Technical Bulletin

Bulletin Number: 518 **Revision Number:** _____
Release Date: 6/19/08 **Revision Date:** _____

Subject: Magnetic Discharge Door

Models Affected: All Coke Glass Front Venders, DN5000 & DN3000

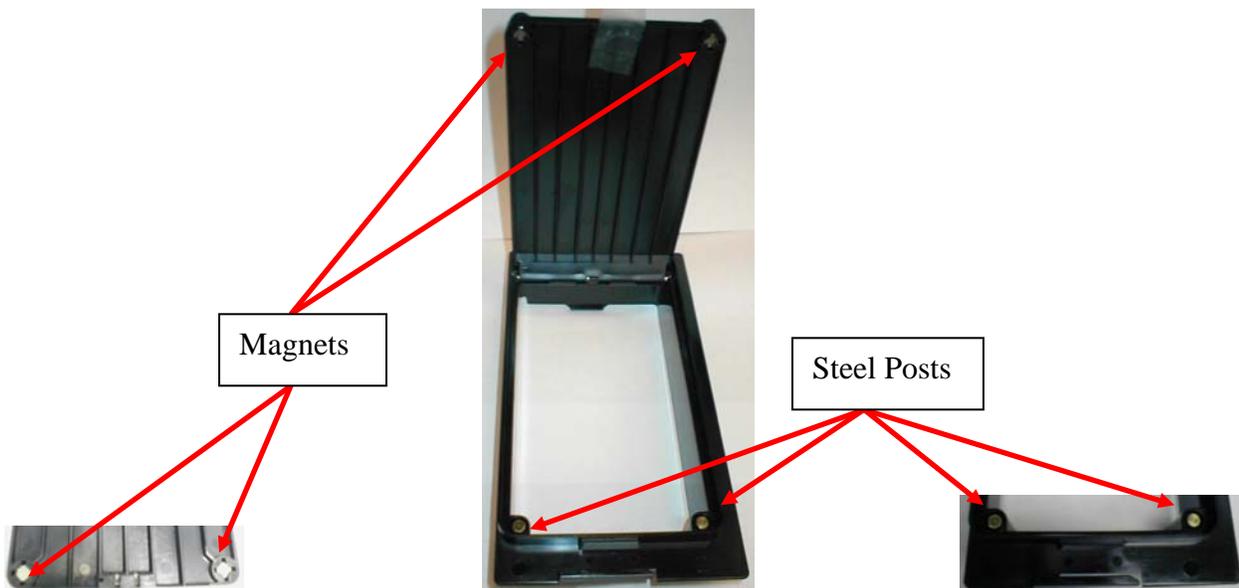
Reason: To enhance security of the discharge door of Coke Glass Front Venders in the field. New Discharge Frame Back Assembly has a Discharge Door with 2 magnets in the bottom corners (See Figures below) and Frame Back with 2 steel posts in the bottom corners (See Figures below) to close the door securely after a vend.

Order: 1 – 801,812,410.51 Discharge Frame Back Assembly with Magnetic Door

Order Discharge Frame according to Vender serial break.

- 1 – 801,817,51x.x1 Discharge Frame for venders serialized 0001-8152BA and higher
- 1 – 801,812,91x.x1 Discharge Frame for venders serialized prior to 0001-8152BA
